ITEM: 6.1	COMMITTEE OF ADJUSTMENT REPORT SUMMARY MINOR VARIANCE APPLICATION FILE NUMBER A027/23 86 HAILSHAM CT WOODBRIDGE
------------------	--

**COMMITTEE OF ADJUSTMENT REPORT
MINOR VARIANCE APPLICATION
A027/23
86 HAILSHAM CT WOODBRIDGE**

ITEM NUMBER: 6.1	CITY WARD #: 3
APPLICANT:	Shamin Ali & Zhanna Prokopchuk
AGENT:	Square Design Group
PROPERTY:	86 Hailsham Court, Woodbridge
ZONING DESIGNATION:	See Below
VAUGHAN OFFICIAL PLAN (2010) DESIGNATION:	Vaughan Official Plan 2010 ('VOP 2010'): "Low-Rise Residential"
RELATED DEVELOPMENT APPLICATIONS:	None
PURPOSE OF APPLICATION:	Relief from the Zoning By-law is being requested to permit the construction of a proposed cabana, swimming pool and installation of related pool equipment and to permit reduced rear yard landscaping requirement.

1 SITE PLAN
A1 1:150

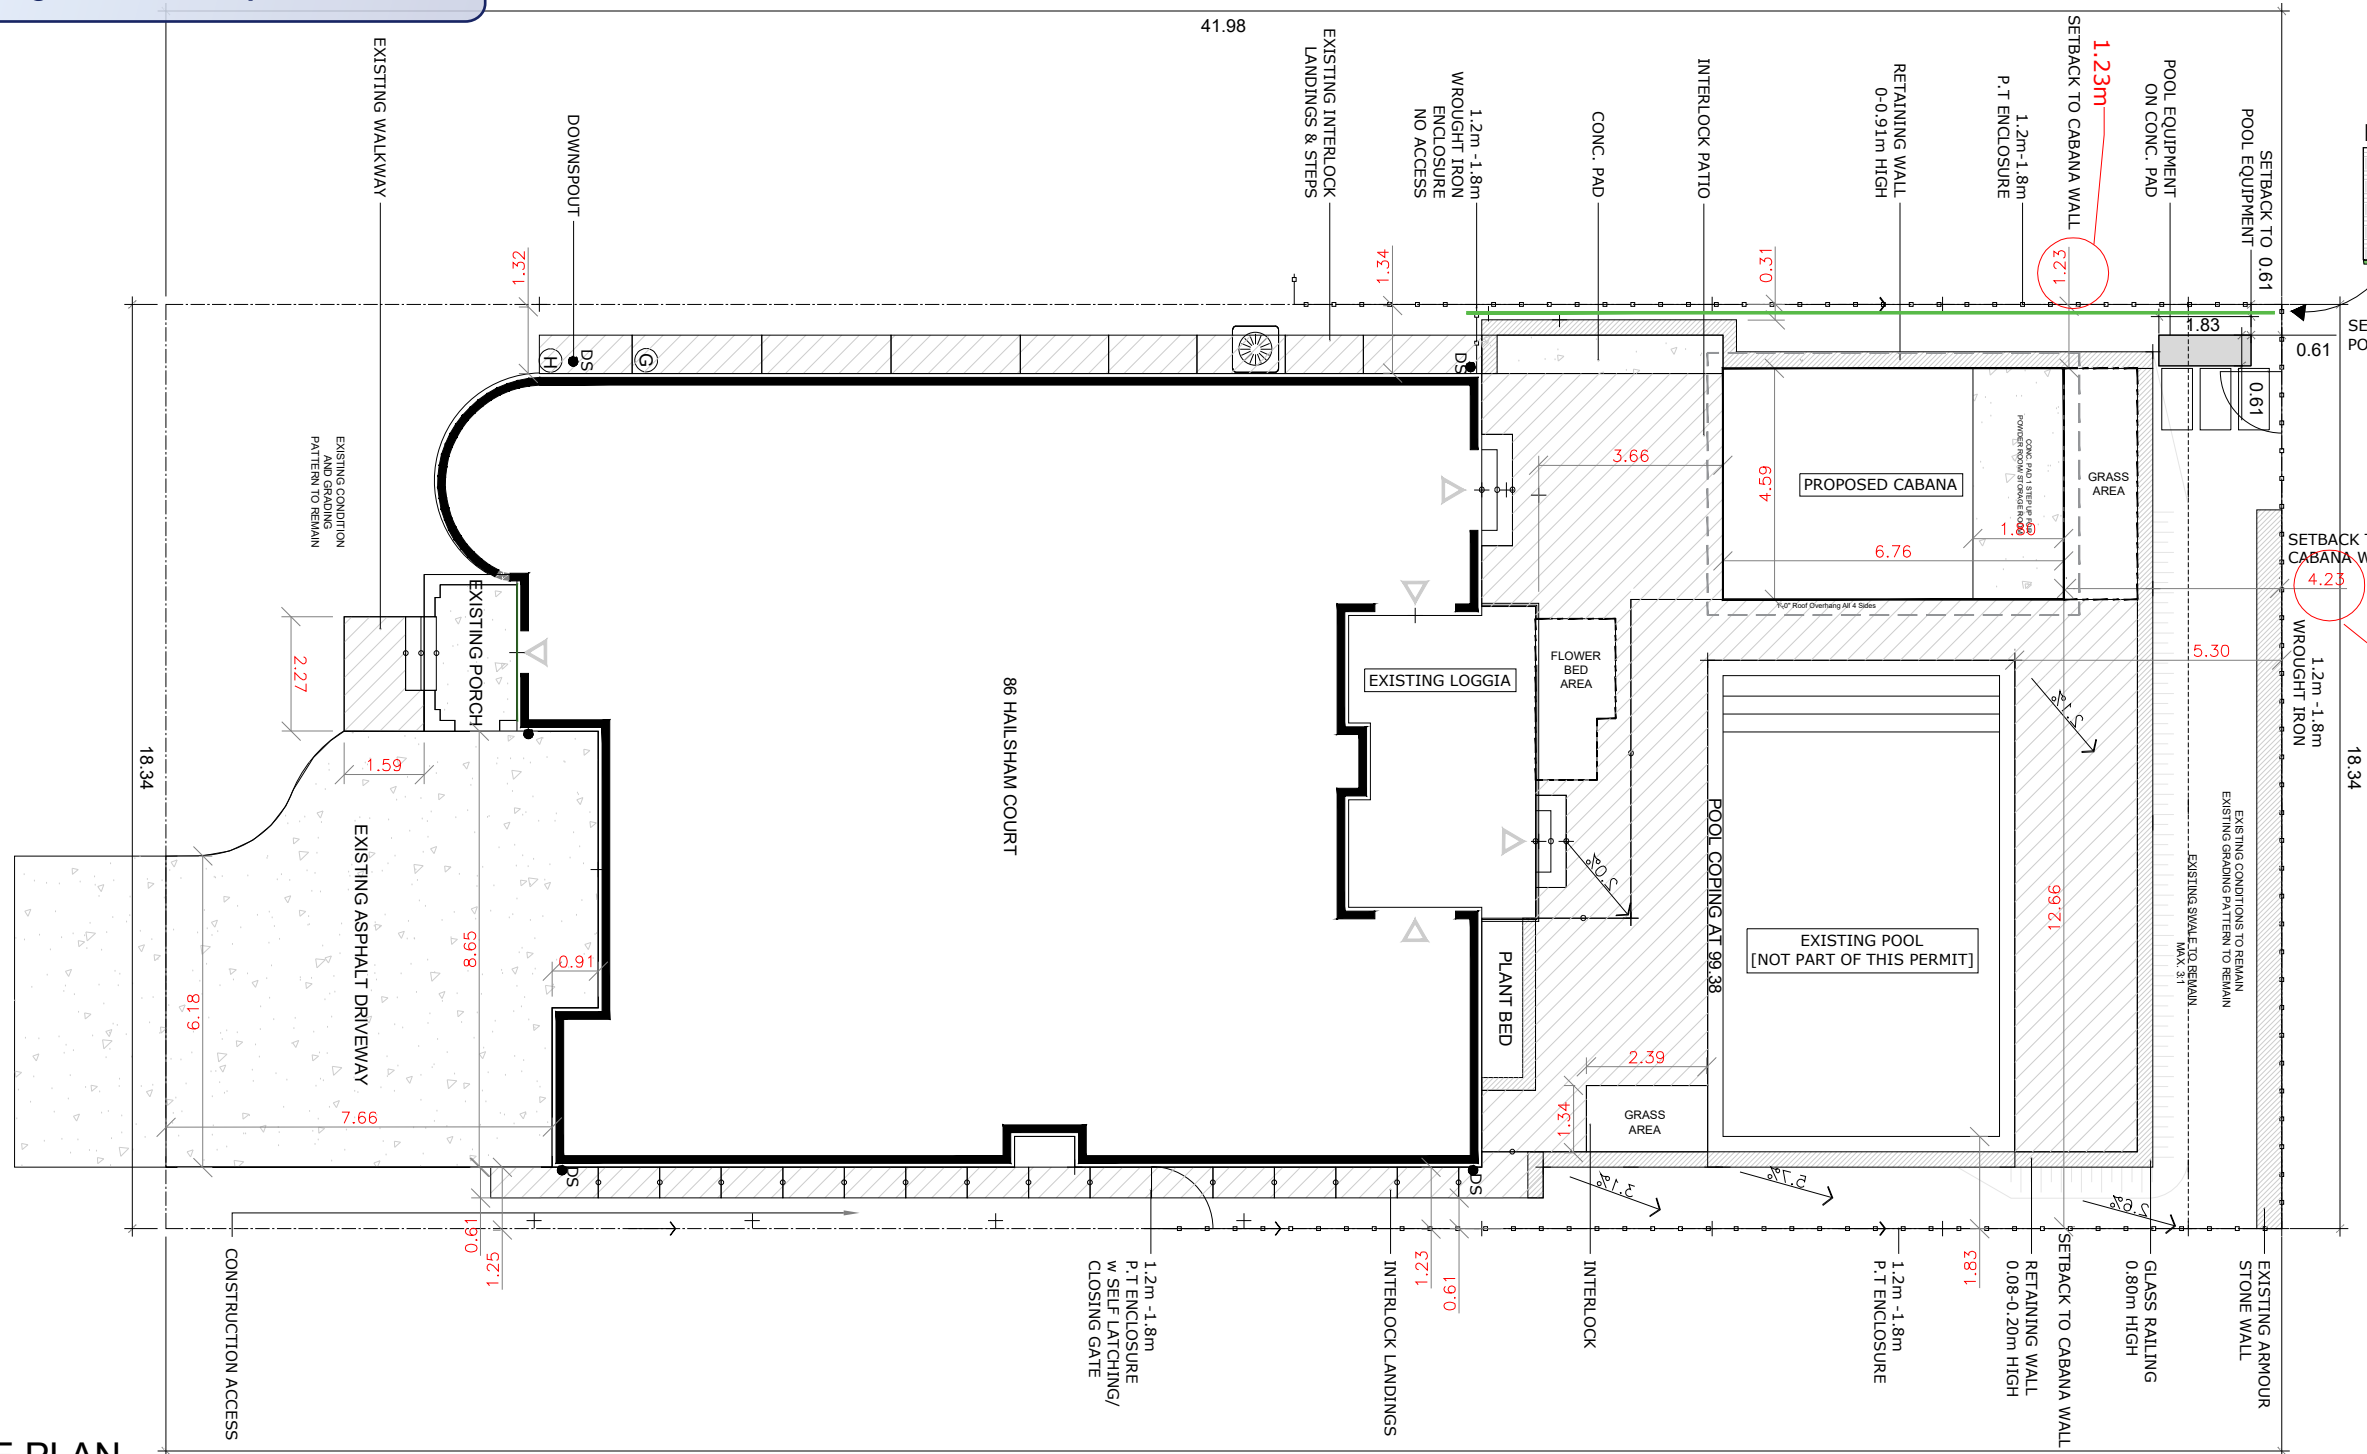
The proposed work by the Owner / Applicant is increasing the lot coverage on the subject property. The added hardscape may have impacts on the City's Storm Water management system. Development Engineering strongly encourages the Owner / Applicant introduce Low-Impact Development (LID) measures (e.g., bioswales, permeable pavers, rain gardens, rain barrels etc.) to reduce the impacts to the stormwater system. Should further information be required, please contact the Development Engineering COA reviewer.

The Development Planning Department has no objection to Variances 1, 2 and 5 for the proposed cabana. The cabana is a partially open structure with a hip roof design that has an enclosed room on the west side. The cabana, as a partially open structure, presents less mass overall relative to a fully enclosed structure. Hedge plantings are proposed to the north of the cabana to assist in screening it from the neighbouring property. The 0.45 m increase in height for the cabana is not anticipated to pose adverse use or massing impacts to the neighbouring properties as the hip roof design ensures that the full extent of the height relief is for an angled, shingled roof with a ridge situated further away from the rear and interior side lot lines. As such, the cabana will not pose adverse massing and privacy impacts to the neighbouring properties and provides an appropriate spatial separation for maintenance access.

The Owners have revised their application to provide additional rear yard soft landscaping upon recommendations from the Development Planning Department. The Development Planning Department has no objection to Variances 4 and 7 for the revised rear yard soft landscaping as the reduction in soft landscaping is minor in nature and will maintain an appropriate balance of soft landscaping to facilitate drainage, reduce urban heat island effects, and facilitate the establishment of vegetation. The Development Engineering Department has also reviewed the proposal and is satisfied that drainage in the rear yard will be maintained.

Development Planning Recommended Conditions of Approval: That the final Landscape Plan be approved to the satisfaction of the Development Planning Department.
